LINOTYPE IMPROVEMENT INFORMATION SHEET

No. 279

ASSEMBLING ELEVATOR & DELIVERY SLIDE

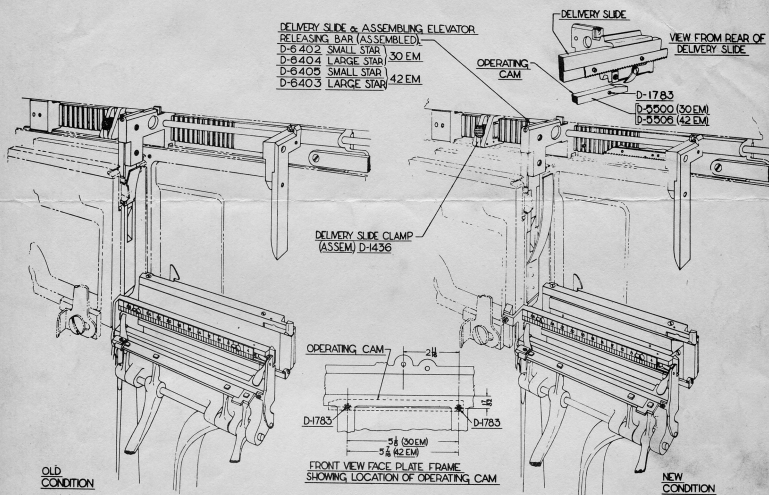
The Self Quadder type Assembling Elevator & Delivery Slide have been added as regular equipment on all new machines. This obviates the need for setting the Delivery Slide Clamp D-1436 to correspond with changing lengths of lines thus aiding the operator by doing away with this operation.

Can be applied to all 30 and 42 Em Machines by substituting new parts as indicated for Delivery Slide. For information in changing over the Assembling Elevator see Improvement Sheet #275. See Mailing Sheets 490 and 520.
